**SP-16-00155:** A site plan for a phased, commercial development with multiple buildings for a mix of retail and quality restaurant and/or fast order food but excluding fast order food-drive-in uses located at 4300 W 24<sup>th</sup> Place. Submitted by Paul Werner Architects, for RPI, LLC, property owner of record.

**ADMINISTRATIVE DETERMINATION:** The Planning Director approves the above-described Site Plan with the requirement that prior to issuance of a building permit the applicant shall provide building elevations and photometric plans for staff review and approval and subject to the following conditions:

**Figure 1: Interior vehicular pattern**

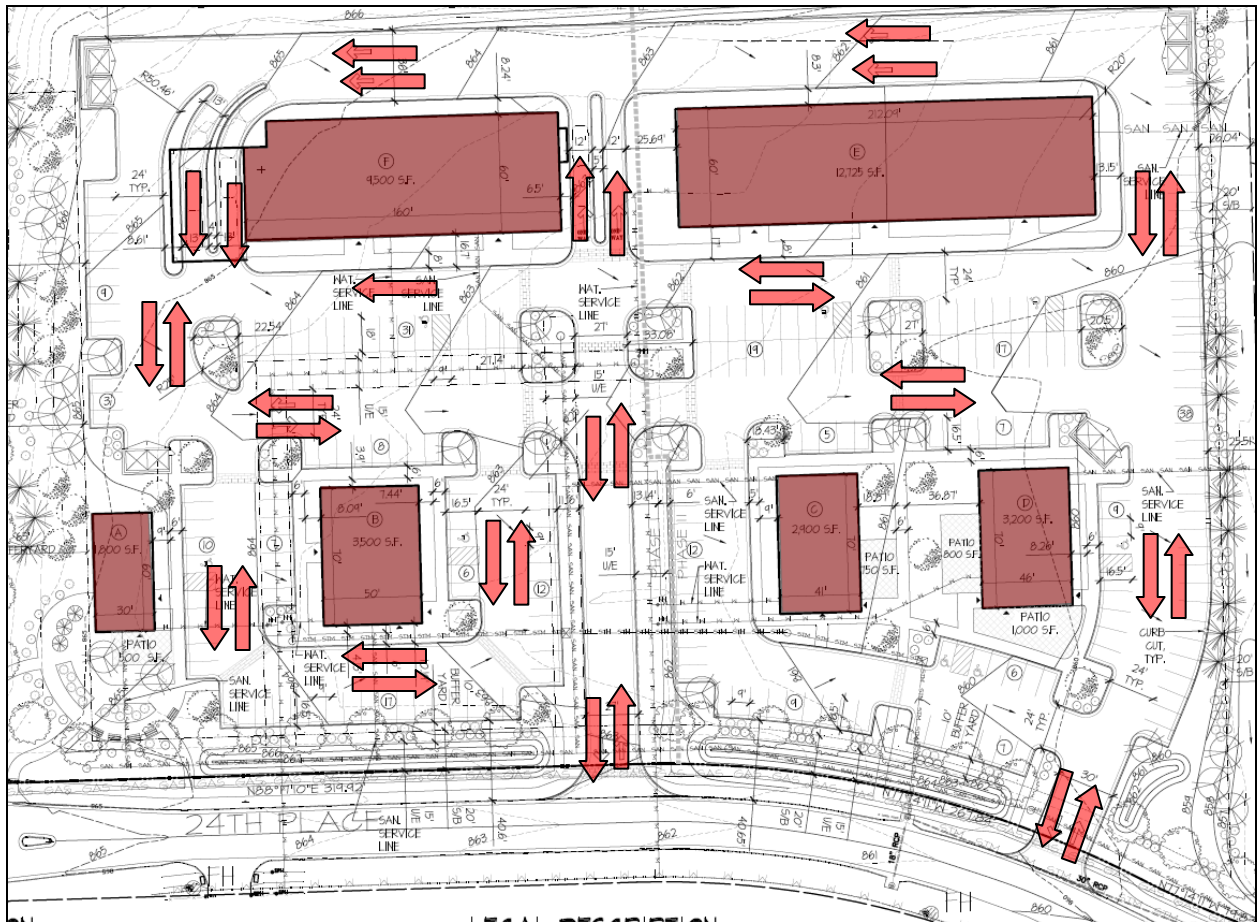
The City Engineer noted that the drive-thru window locations may need to be adjusted based on future review of the tenant space to ensure vehicle stacking requirements are met. The proposed or future bank use located on the west end of Building F appears to provide adequate stacking. The use on the east end of the building may or may not require additional stacking depending on the final tenant.

**Figure 4: Inverness Drive Buffer Yard**

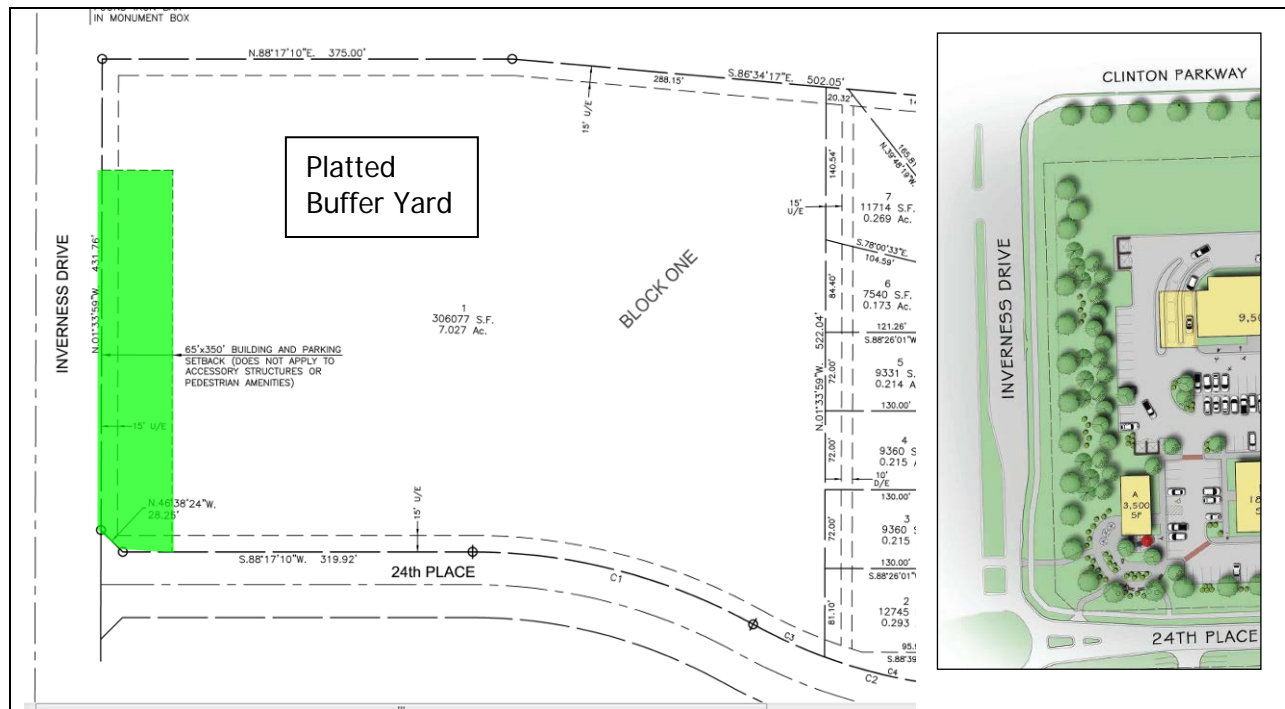
The plan exceeds the required landscape planting standards for screening along Inverness Drive.

**Figure 7: Main Building Entrance**

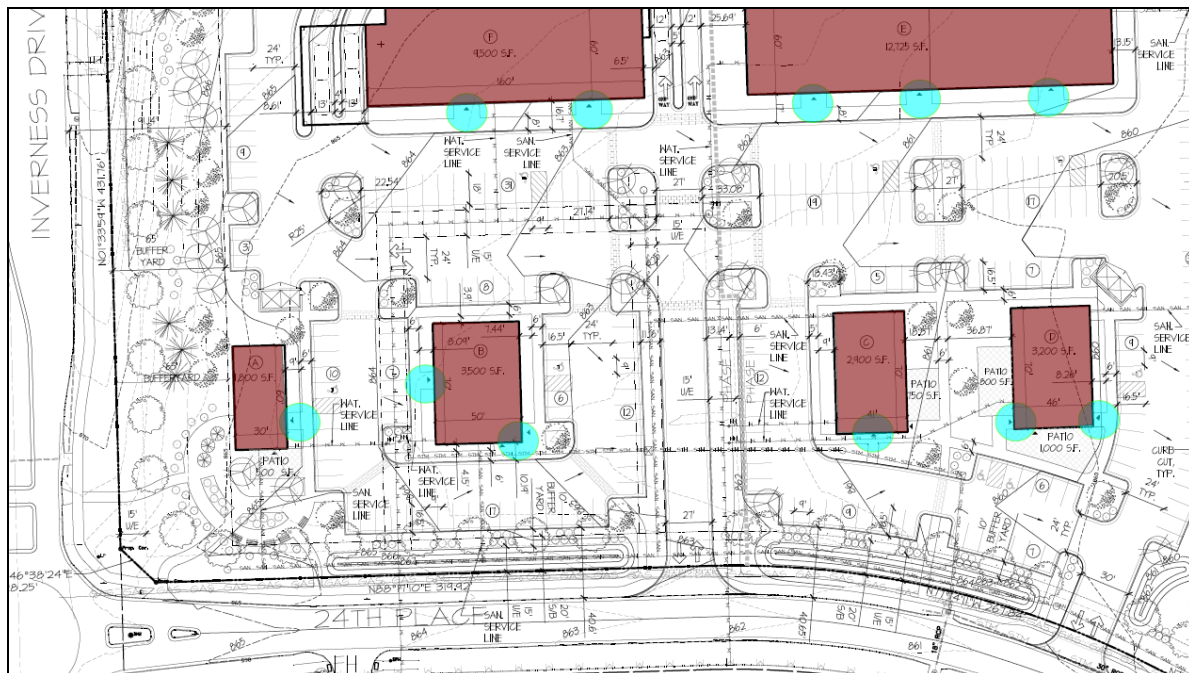
The CN2 district does not allow off-street parking between the street and the main entrance of a building. This standard applies to Buildings A, B, C and D as shown on the site plan.

The building entrances are shown conceptually. As final building elevations are determined building entrances will need to be on the east/west sides of the buildings to comply with the design standard per Section 20-908.
